## Product Change Notification

### PCN-FDC-8552-2023

Business Unit	Product Line Code	Type of Change	Action	Date of Issue
FDC - Field Device Connectors	ABR	Product Change Notification	Notify Distributors and Field	2/15/2023

#### Description for Product Change Notification

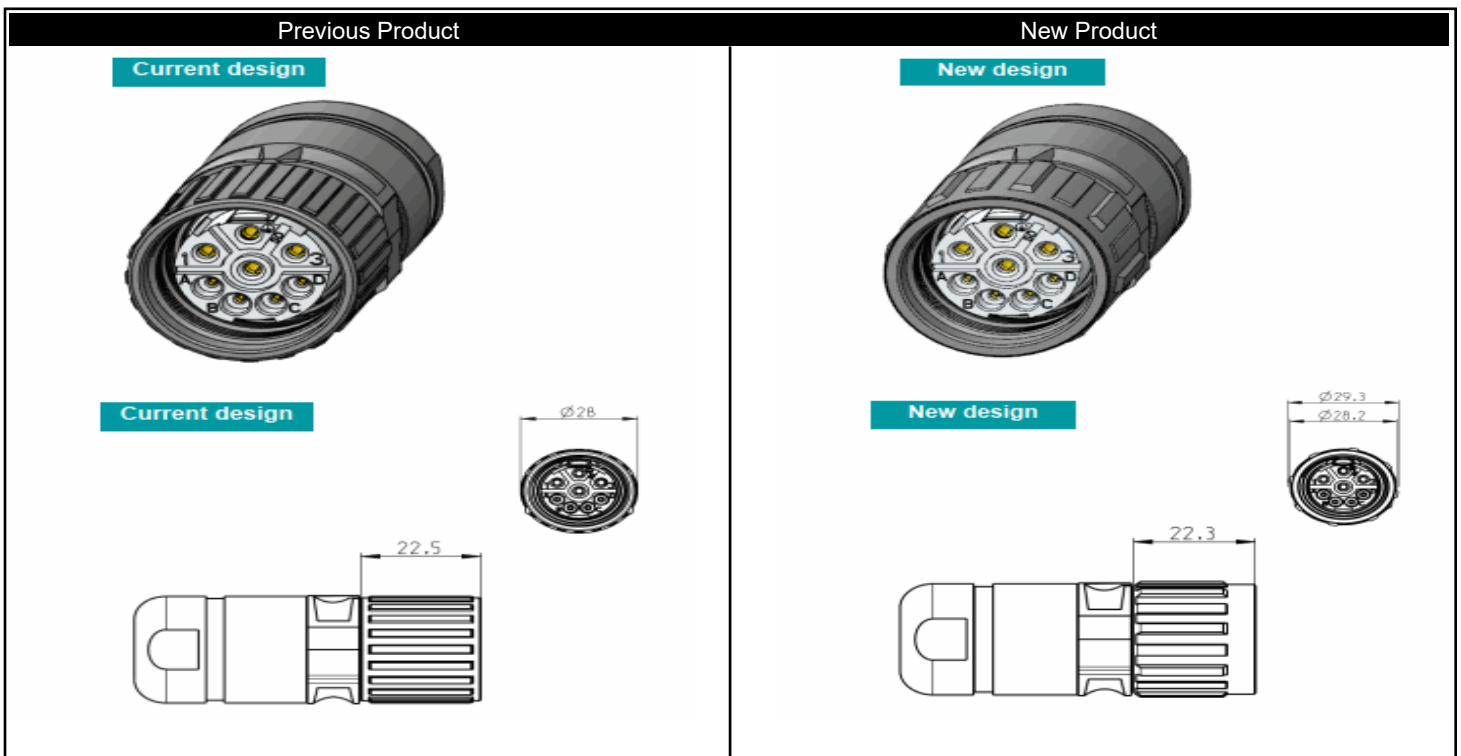
As part of an ongoing improvement process, a design change and material change is being made to the items listed. The change to the knurl design of the SF series, which was planned for 2019, can now be finalized after further technical adjustments.

To improve the bite, the knurl design was adapted using more ridges. Furthermore, the knurl material is changing from brass (turning process) to die-cast zinc (out-of-tool production process). This will improve supply capability and help to clear out existing backlog. Due to the difficult delivery situation, this change needs to be completed in less than 6 months.
